FCC ID: AZ489FT7077

Subject: Class II Permissive Change for PCB and Part Modification and PAG C2PCPX

Product changes illustration and comparison

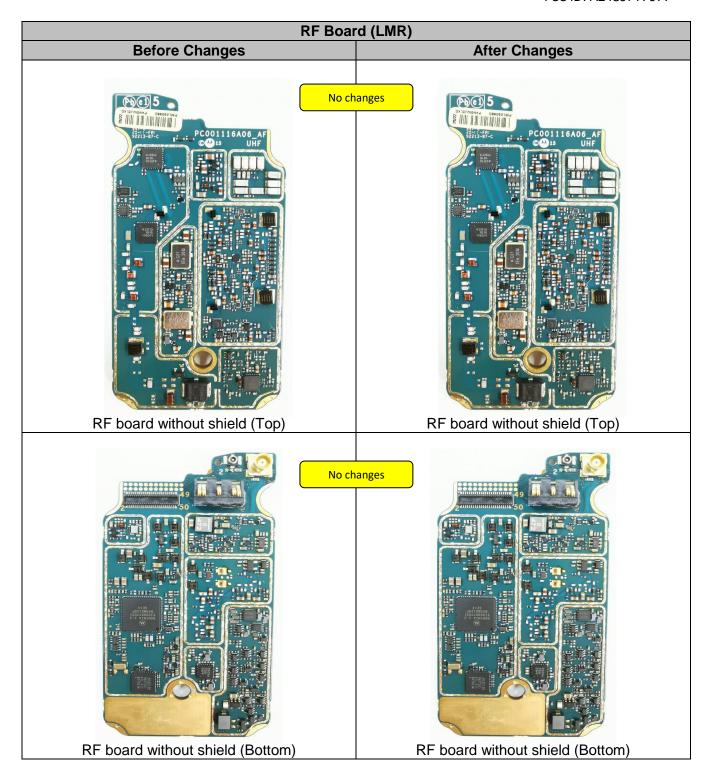
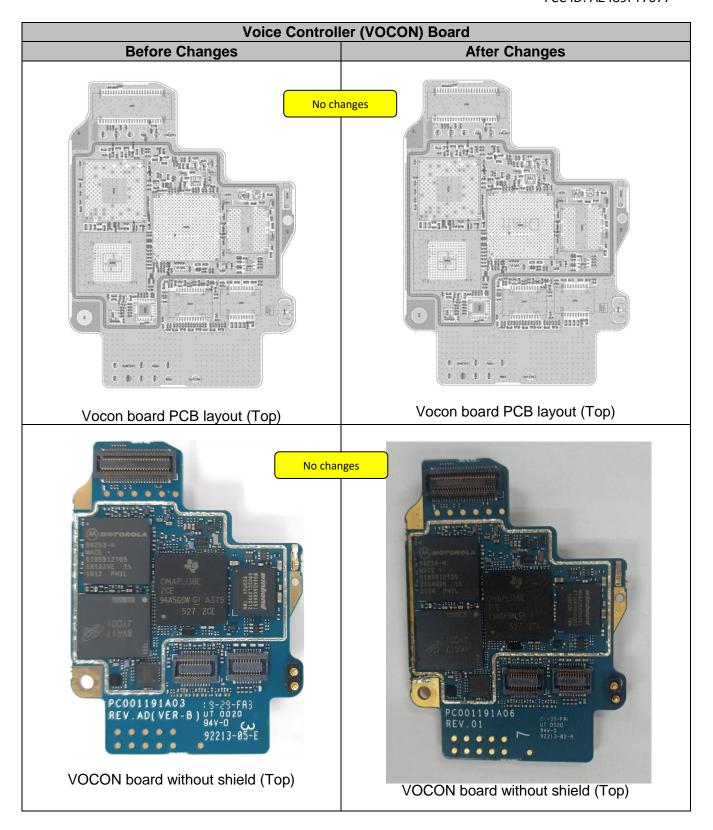
- 1. The changes were triggered due to BT/WLAN chipset part shortage and a new BT/WIFI chipset is replaced.
- 2. Few passive components were replaced at Power Management section (PMIC), BT/WiFi Circuitry, 3.6V Switching Regulator and 3.3V LDO due to new BT/WLAN chipset part design requirement. All replacement parts performance are comparable to the existing parts.
- 3. There is no mechanical change.
- 4. No change to the sales model number.
- 5. Reuse shipping batteries, chargers and accessories.
- 6. No changes to the RF board.

* Changes are marked in yellow box. Orange box indicates the sections under the shield.
